ADDENDUM NO. 01

Project No.24076

Project Name: TFSD Lincoln HVAC Replacement
Address: Twin Falls, Idaho

Date Issued: March 27, 2025

Sheet No:
MD2.01

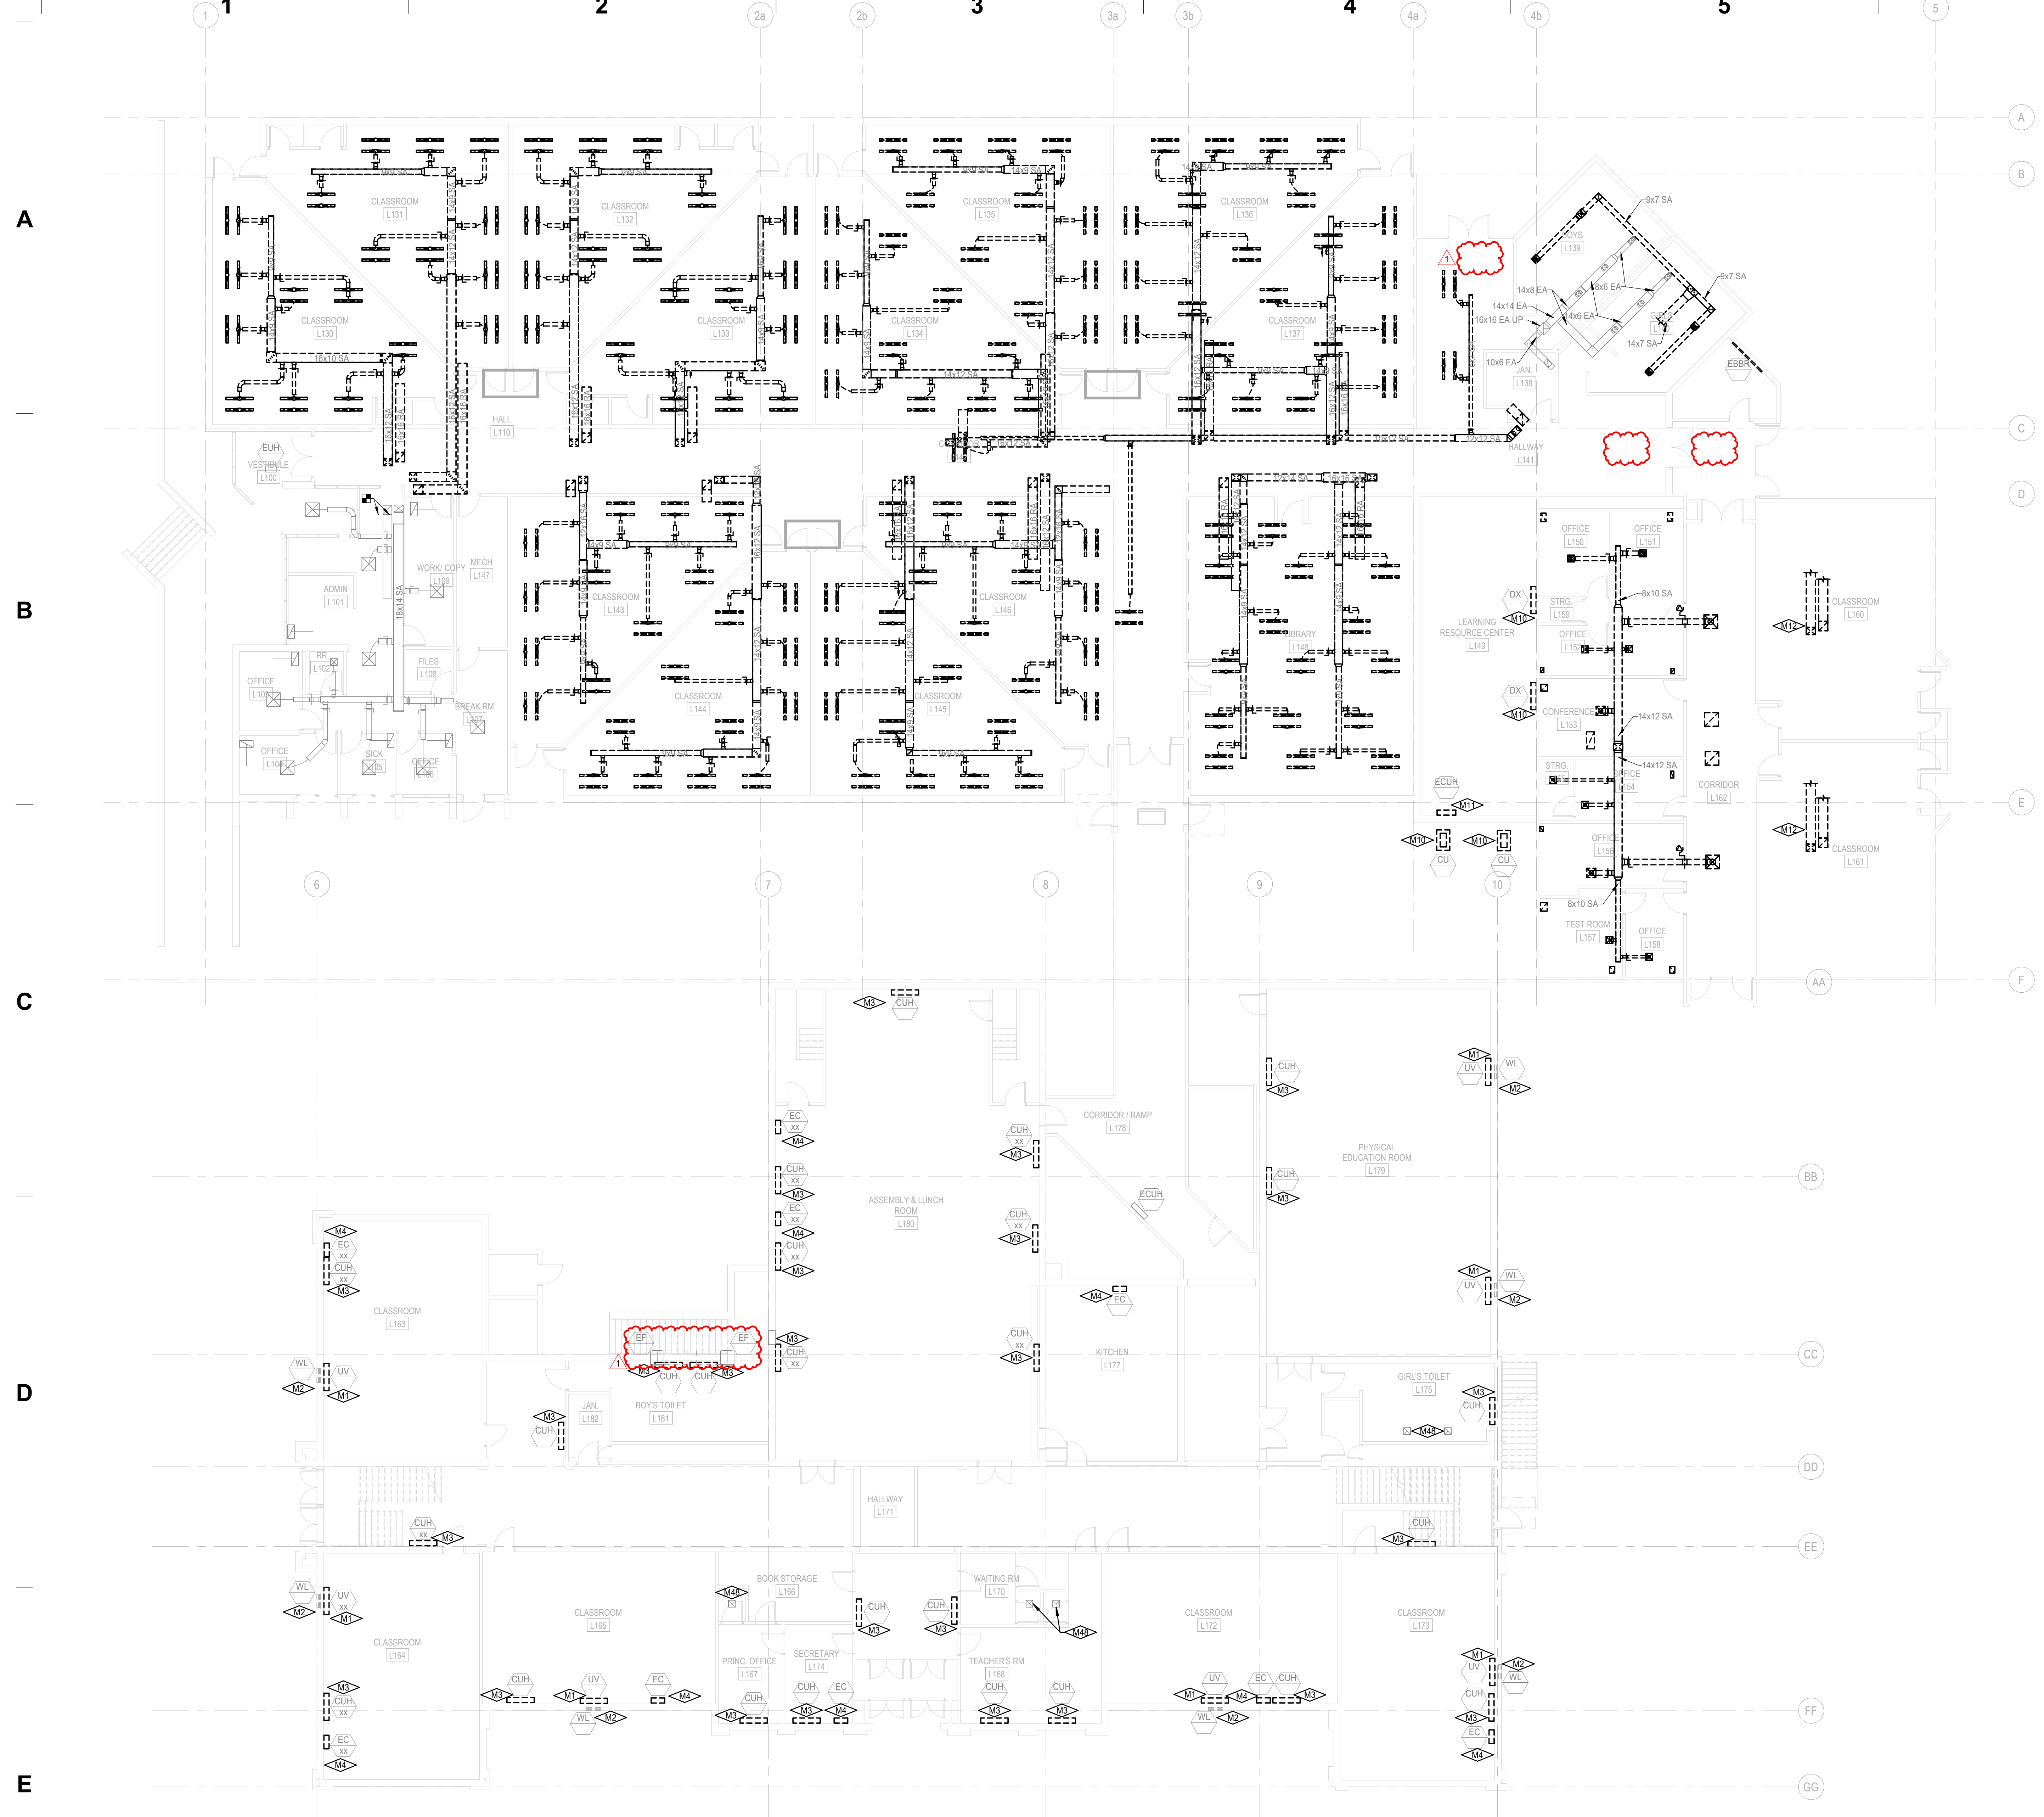
MD2.01 – LEVEL 01 – HVAC DEMOLITION PLAN

1. REMOVED DEMOLITION OF 3 ELECTRIC HEATERS IN CEILING
2. REVISED PLANS TO SHOW 2 EXISTING EXHAUST FANS IN BOY'S TOILET TO REMAIN

Sheet No:
MD2.13

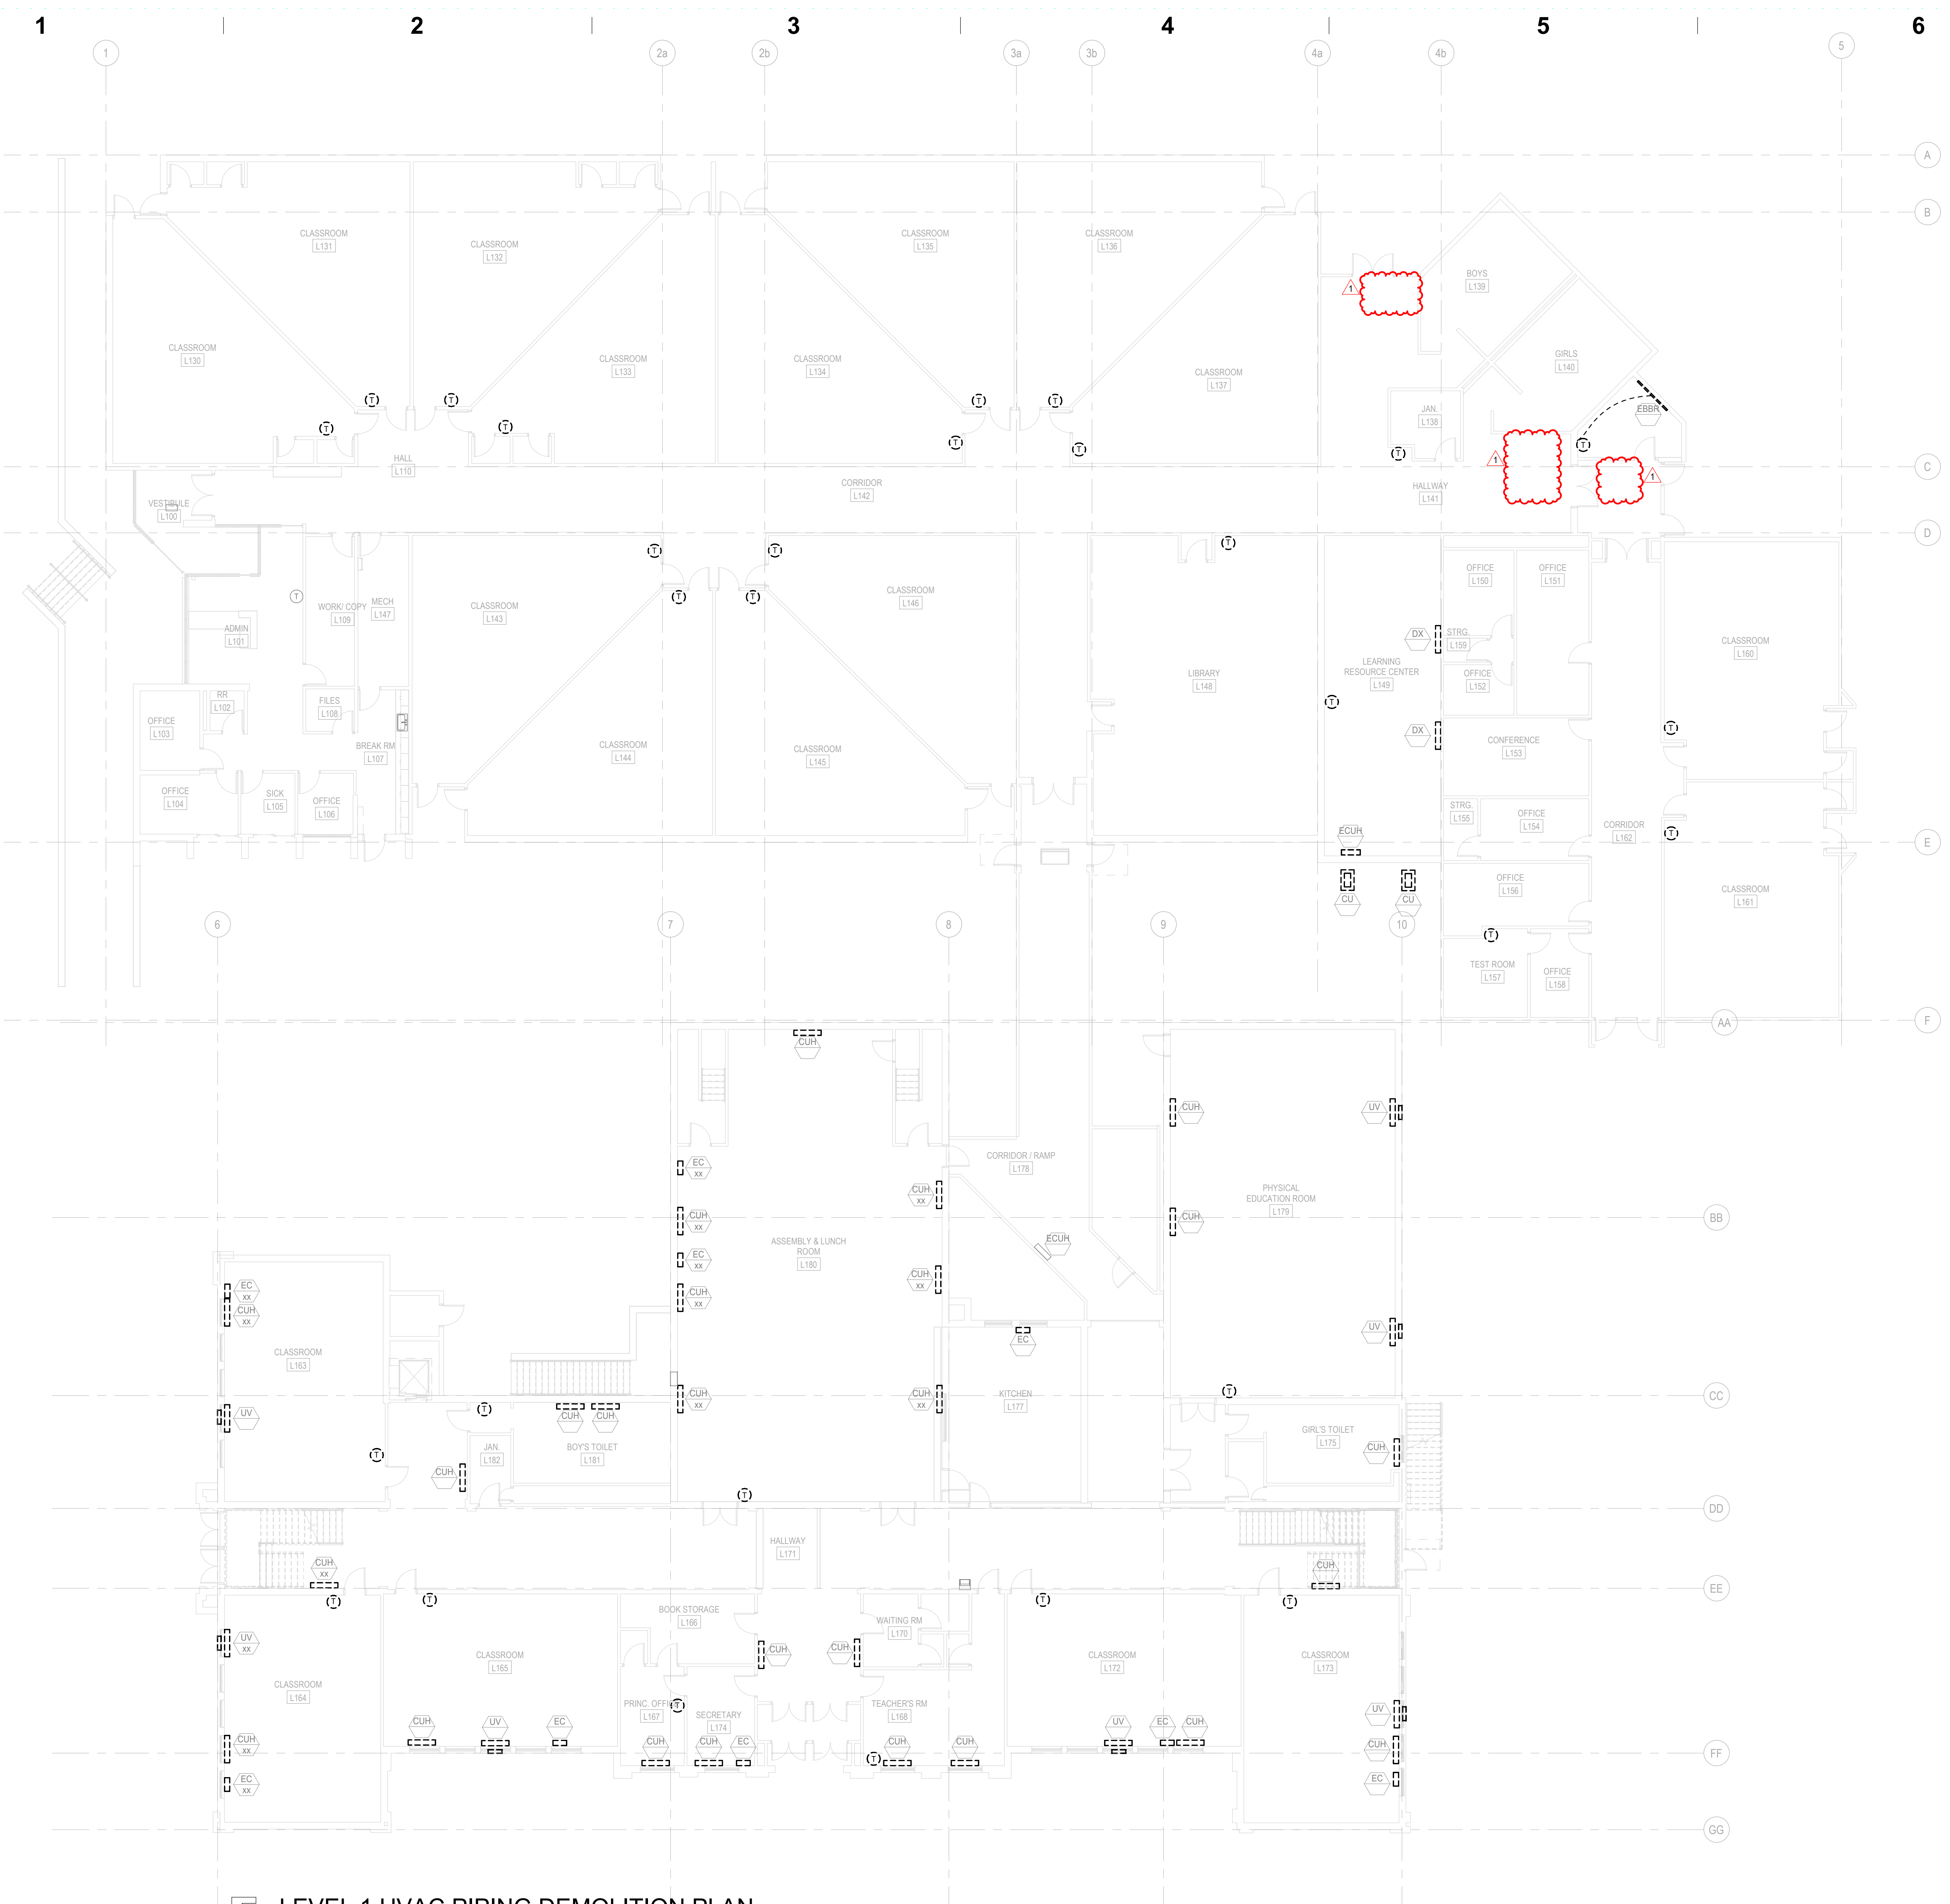
MD2.13 – LEVEL 01 – HVAC PIPING DEMOLITION PLAN

1. REMOVED DEMOLITION OF 3 ELECTRIC HEATERS AND TSTATS
